# ARCHITECTURAL REVIEW COMMITTEE MEMORANDUM

DATE: December 7, 2021 CONSENT AGENDA

SUBJECT: ADHAM CHEHAB AND RINA LAZARIAN-CHEHAB, OWNERS, REQUESTING A MAJOR ARCHITECTURAL APPLICATION FOR THE CONSTRUCTION OF A NEW 4,220-SQUARE FOOT SINGLE-FAMILY HOME, INCLUSIVE OF A FOUR-CAR GARAGE LOCATED ON A MAJOR THOROUGHFARE AT 2260 NORTH SUNRISE WAY (CASE 3.4293), ZONE R-1-C, APN 501-283-012 (RB).

Site plan showing:  
 Trash and recycling bin storage  
 AC unit  
 Pool equipment enclosure  
 Six foot high cinderblock wall to cover the existing wood fence

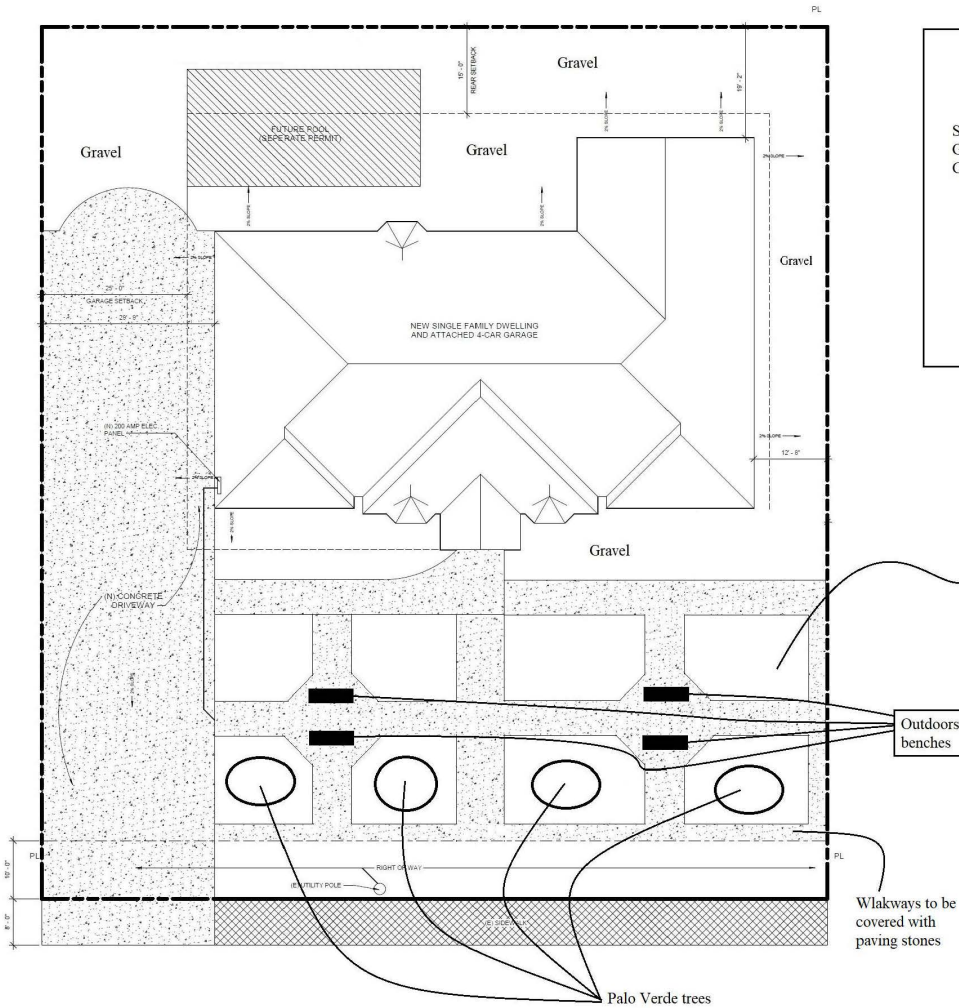
8.	<i>The proposed landscape plan is consistent with all applicable zoning requirements, including any streetscape requirements, landscape buffer requirements, and screening requirements;</i> The project is new construction utilizing a combination of xeriscape and drought tolerant plant species and benches to create perimeter buffered landscape areas of the property and respect streetscape visibility concerns. Staff recommends additional	Y, as conditioned

<i>Criteria and Findings [PSZC 94.04.00(E)]</i>	<i>Compliance</i>
	landscaping within the buffer area along the sidewalk and right of way adjacent to the property line.

- b. The Applicant shall plant additional landscaping within the buffer area along the sidewalk and right of way adjacent to the property line. Said landscape shall be consistent with the proposed design and shall be shown on a final landscape plan that is reviewed and approved as part of Condition PLN 2.

Proposed landscaping plan  
 Chehab residence  
 2260 N. SUNRISE WAY  
 PALM SPRINGS, CA 92262  
**LEGAL DESCRIPTION:**  
 APN # 501-283-012  
 LOT AREA - 20,250 SQ FT , (0.46) ACRES

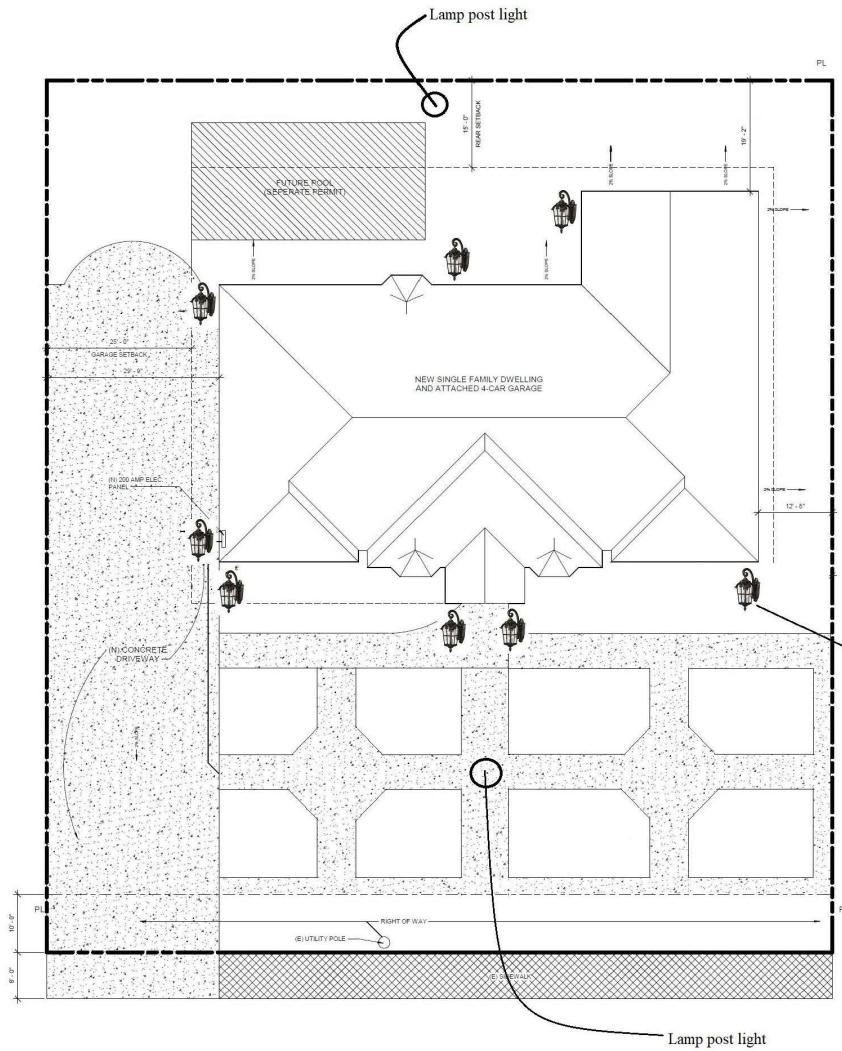
1. The Applicant shall select alternate plant species to the crawling sedum from the CVWD Lush and Efficient handbook.
2. The Applicant shall submit a revised landscape plan to include landscaping within the right-of-way area behind the sidewalk that is consistent with the proposed landscape design.

7.	<i>The proposed landscape plan is consistent with the requirements of PSMC Chapter 8.60;</i> The project generally proposes drought-tolerant landscape species compliant with the Coachella Valley Water Districts Lush and Efficient handbook; Staff recommends alternate plant material to crawling sedum which will comply with PSMC Chapter 8.60.	Y, as conditioned

- PLN 11. Architectural Review Committee.
- a. The Applicant shall select an alternate plant species for the crawling sedum from the CVWD Lush and Efficient handbook.
